Product / Process Change Notification (PCN)							
<input checked="" type="checkbox"/> Major Change <input type="checkbox"/> Minor Change							
PCN Number: PCN_WPME-FISM_1769205341_20250120 Affected Series: WPME-FISM Affected Part Number: 1769205341 PCN Date: 2024-12-20 (YYYY-MM-DD) Effective Date: 2025-01-20 (YYYY-MM-DD)	Change Category: <input checked="" type="checkbox"/> Equipment/Location <input checked="" type="checkbox"/> General Data <input checked="" type="checkbox"/> Material <input type="checkbox"/> Process <input checked="" type="checkbox"/> Product Design <input checked="" type="checkbox"/> Shipping/Packaging <input checked="" type="checkbox"/> Supplier <input type="checkbox"/> Software						
Contact: Product Management Phone: +49 (0) 7942 - 945 5001 Fax: +49 (0) 7942 - 945 5179 E-Mail: pcn.eisos@we-online.com	Datasheet Change: <input checked="" type="checkbox"/> Yes <input type="checkbox"/> No Attachment: <input checked="" type="checkbox"/> Yes <input type="checkbox"/> No						
DESCRIPTION OF CHANGE: <p>Due to an improvement of the production capability, Würth Elektronik eiSos has shifted the production of the affected part number to a new factory location.</p> <p>Wit

Figure 17: 1769205x41 block Diagram.

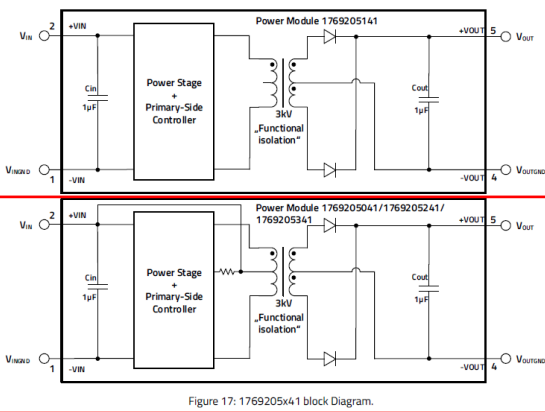
The modules still are based on either a full bridge or a push-pull topology. In some cases the single part number topology switched from previous full bridge topology to a push-pull topology or vice versa. The topology change is indicated in the BLOCK DIAGRAM chapter.

The Mag³C power module 1769205141 is based on full bridge topology whereas the Mag³C power modules 1769205041 / 1769205241 / 1769205341 are based on a push-pull converter. All modules have an integrated IC, rectifying diodes, input and output capacitors and a transformer.
